**Application for Minor Amendments
to Reserved Matters Approval
For Building T5 2013/2481/P**

King's Cross Central General Partner Ltd
Aga Khan Foundation (United Kingdom)

December 2014

Drawing Title
General Arrangement
East Elevation Flank Wall

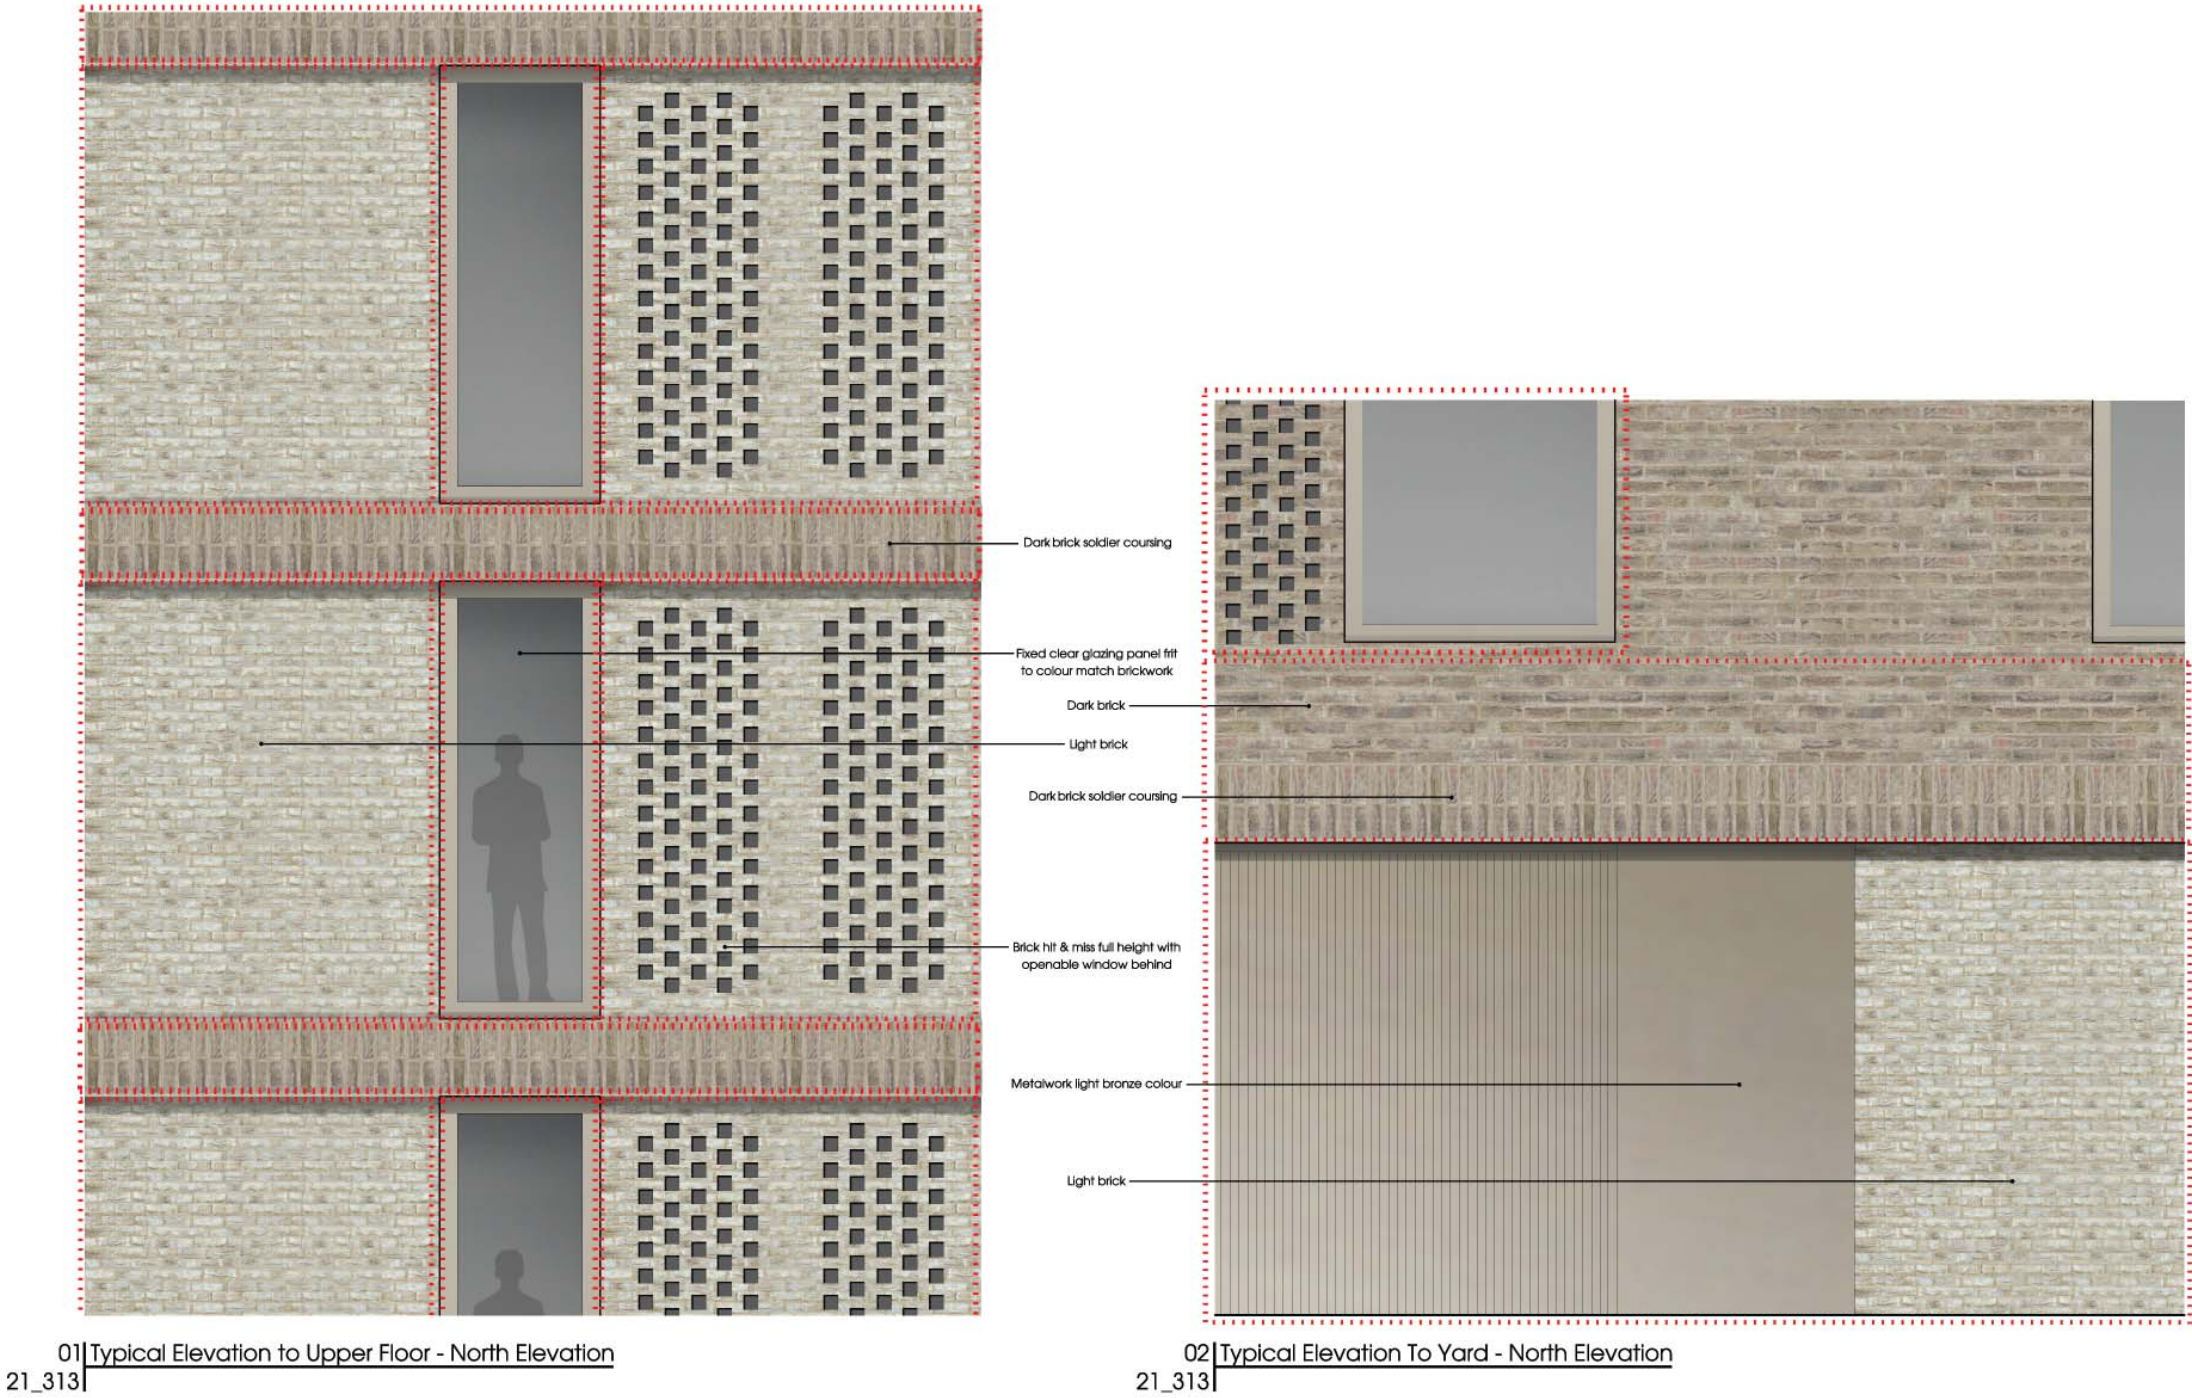
Revisions Key
1. Removal of setback brickwork level 00
2. Soldier course brickwork added
3. Soldier course brickwork on same plane as glazing
4. Removal of glazing to core where indicated levels 02-11

A darker stretcher bond brickwork, consistent with the remainder of the facade, has been introduced at ground floor level in lieu of the lighter coloured setback brickwork, for consistency of the elevation to the base of the building. This is amendment 1 on drawing 426 00_234 P0 submitted for information and shown on drawing 426 00_234 P1 submitted for approval.

Additional bands of soldier course brickwork have been added at levels 1 and 2; consistent with the northern elevation. This is shown as amendment 2 on 426 00_234 P0 submitted for information and shown on drawing 426 00_234 P1 submitted for approval.

The central 'carved' section of the eastern elevation flank wall has been amended to match that section of the northern elevation. The dark banding has been flattened and lightened into a band of soldier coursing, flush with the glazing. This is amendment 3 on 426 00_234 P0 submitted for information and shown on drawing 426 00_234 P1 submitted for approval.

A line of glazing from levels 02-11, of the internal stair cores, has been removed. The line of adjacent glazing has also been slightly increased in size for additional strength and balance to the elevation. This is amendment 4 on 426 00_234 P0 submitted for information and shown on drawing 426 00_234 P1 submitted for approval.
